**SUBJECT: Fort Calhoun Station Unit No. 1, Response to Request for Additional Information on the Revised Relaxation Request for First Revised Order (EA-03-009) Establishing Interim Inspection Requirements for Reactor Pressure Vessel Heads at Pressurized Water Reactors**

**Response to Request for Additional Information on the Revised  
Relaxation Request for First Revised Order (EA-03-009) Establishing  
Interim Inspection Requirements for Reactor Pressure Vessel Heads at  
Pressurized Water Reactors**

The basic component arrangement of the system is shown in Detail “A” (upper components) and Detail “B” (lower components). The components of interest in this discussion are as follows:

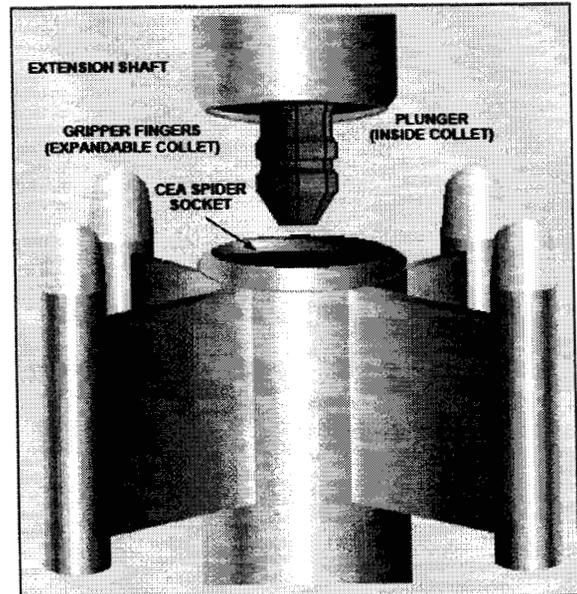
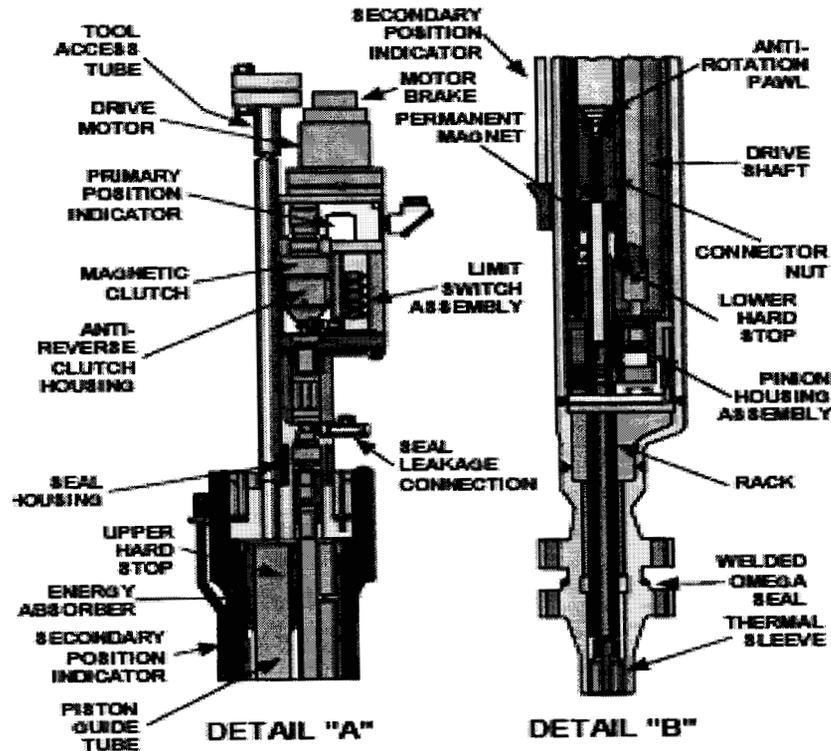
Please provide a detailed explanation of the hardship associated with removal of the thermal sleeve for Control Element Drive Mechanism (CEDM) penetration nozzle 25.

The rod control system at Fort Calhoun Station Unit No. 1 (FCS) is a unique design that uses a rack and pinion CEDM. Palisades is the only other plant with rack and pinion CEDMs, but their configuration under the reactor pressure vessel (RPV) head is very different from FCS, in that their CEDM extension shafts can be removed from the top. The rack and pinion design imposes a significant constraint on performance of a RPV head inspection because the CEDM extension shaft that connects the drive mechanism to the Control Element Assembly (CEA) remains installed in the RPV head nozzle when the reactor is disassembled. The presence of the CEDM extension shaft severely limits access to the nozzle inside diameter (ID) for inspection purposes. Inspection access is further complicated by the thermal sleeve that is installed in the annulus between the CEDM extension shaft and the CEDM nozzle.

FCS has a “scram weight” at the end of each CEDM extension shaft that precludes CEDM extension shaft removal from the top of the RPV head, necessitating their removal from below the RPV head (See Reference 1, Attachment 1, Figure 3, Page 15). Palisades does not have these weights and can remove their extension shafts from the top of the RPV head.

- Extension shaft assembly – supports the CEA spider
- Connector bolt – supports the extension shaft assembly
- Connector nut – supports the connector bolt
- Rack raises and lowers the rack extension to raise the CEA

The CEDM extension shaft assembly is inserted through the CEDM nozzle from underneath the RPV head and extends through the rack into the piston guide tube.

During initial assembly of the RPV head, personnel were positioned in the reactor vessel and the CEDM extension shafts were manually guided into the CEDM nozzle and mated with the CEDM rack assembly. The CEDM extension shafts have never been removed during the 30+ years of FCS operation. The CEDM extension shafts are approximately 21 feet long and are an engineered component which cannot be cut. The location of the CEDM extension shaft affects pinion assembly alignment for raising and lowering the CEA and the dashpot assembly, which can affect CEA drop time. Removal of these extension shafts can allow accumulated debris to move into these sensitive locations.

In order to remove the CEDM extension shaft on CEDM nozzle 25, the RPV head will be installed on the reactor vessel and the CEDM extension shaft will be lowered until it rests on the CEA spider. The CEDM connector nut will then be removed and the reactor head will be lifted and placed on the head stand. It is anticipated that the CEDM extension shaft will be left resting in the Upper Guide Structure in the reactor vessel. However, since this operation has never been performed, it is not certain that the CEDM connector bolt will disengage smoothly from the CEDM rack assembly and slide downward while the RPV head is being lifted. Additional rack extensions may need to be removed to gain proper clearance and a pathway to access CEDM nozzle 25.

With the CEDM extension shaft(s) removed, the RPV head will be placed in the head lay down area. The configuration of the thermal sleeve cutting equipment requires the RPV head to be raised approximately two feet above the normal resting height. Due to the tight clearances in this area, this additional two feet of height will require removal of interferences and rotating the RPV head into an off-normal orientation. The thermal sleeve will be cut above the CEDM nozzle inspection area and removed. The cutting operation will be performed using precision cutting equipment to avoid any possibility of damage to the CEDM nozzle ID. Industry experience has shown, however, that there is a risk of introducing tool marks on the ID of the nozzle. Special cutting equipment is required to perform this operation because the thermal sleeve will be cut approximately 24 inches above the bottom of the CEDM nozzle. Once the thermal sleeve has been cut and removed, additional special tooling will be used to reinstall the original "flare" on the remaining end of the thermal sleeve. The flare is required to prevent interference with the CEDM rack as it raises and lowers the CEA.

When the thermal sleeve has been removed, the ID inspection of CEDM nozzle 25 can be completed with the normal eddy-current inspection equipment used for the RPV head inspection. For re-assembly after completion of the inspection, the reactor vessel head will be positioned approximately nine feet above the reactor vessel and tooling will be inserted through the tool access tube into the space below the RPV head. The tooling will then be threaded into a connection on the top of the CEDM connector bolt and the CEDM extension shaft assembly will be hoisted up through the CEDM nozzle and mated with the CEDM rack assembly.

Connecting the cable to the CEDM connector bolt will be a manual operation that must be performed under the reactor vessel head on components that have a measured contact dose reading of 3 rem. The CEDM extension shaft will also need to be manually oriented during the hoisting operation to ensure that it mates properly with the CEDM rack assembly. This evolution is both technically and radiologically challenging and has never been performed since initial assembly of the reactor. Two of the most significant technical challenges are suspending the RPV head in a stable configuration approximately nine feet above the reactor vessel and allowing safe personnel access to the area underneath the RPV head. An additional uncertainty is the ability to properly realign the CEDM extension shaft with the rack assembly. The clearances between the two components are very tight and the CEDM extension shaft must be inserted upward

through the entire length of the rack assembly. Once the CEDM extension shaft has been reinstalled, reactor reassembly can be performed in accordance with the normal sequence of refueling activities. There is no way to test for proper re-assembly until the CEA exercise tests, including rod drop times, are performed. Any problem emerging at that time would require RPV head disassembly.

The CEDM extension shafts are 21 feet long and the upper end is 0.875 inch in diameter. The upper end is internally and externally threaded, and slotted. The internal thread that would be used for suspending the extension shafts for removal and reinstallation is only 0.31 inch diameter and 0.5 inch minimum full thread depth. Extension shaft lower ends will not withstand accidental dropping. A re-assembly tool will require a tapered lower end. Without such a guide taper, the top of the extension shaft may hang up on the lower end of the rack during reinstallation. Excessive pulling force could break the thread and drop the extension shaft to the floor.

An "As Low As Reasonably Achievable" (ALARA) plan and dose estimate has been prepared for the sequence of activities described above. The dose estimate was prepared for the activities required to complete inspection of the remaining 80 degrees on the ID of CEDM nozzle 25. The total estimated dose to complete inspection of CEDM nozzle 25 is estimated at 10 rem, including allowances for difficulties associated with first-time performance of the CEDM extension shaft removal. Many of the activities must be performed regardless of the number of CEDM extension shafts and thermal sleeves requiring removal. Therefore, the estimated dose to remove one CEDM extension shaft and thermal sleeve is much higher than the estimated dose per nozzle if all extension shafts and thermal sleeves were to be removed.

Therefore, in summary, OPPD considers that completion of the inspection of CEDM nozzle 25, due to the technical and radiological challenges involved, would result in hardship or unusual difficulty without a compensating increase in the level of quality and safety.
